SERVICE - INFO

MERCEDES – 233 0001 14 – 310/330 TGU6

UNIMOG & MB-TRAC

New design / Neues design / Nouvelle conception / Nuovo design / Nuevo diseño

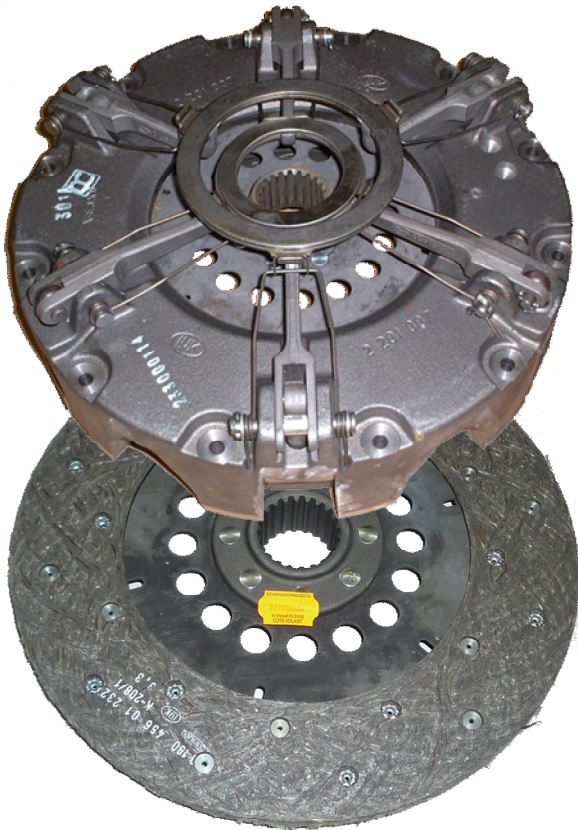
For improved PTO performance LuK 233 0001 14 is now fitted with captive sintered PTO disc.
Fully interchangeable with no modifications to engine or flywheel.

No change to part number.
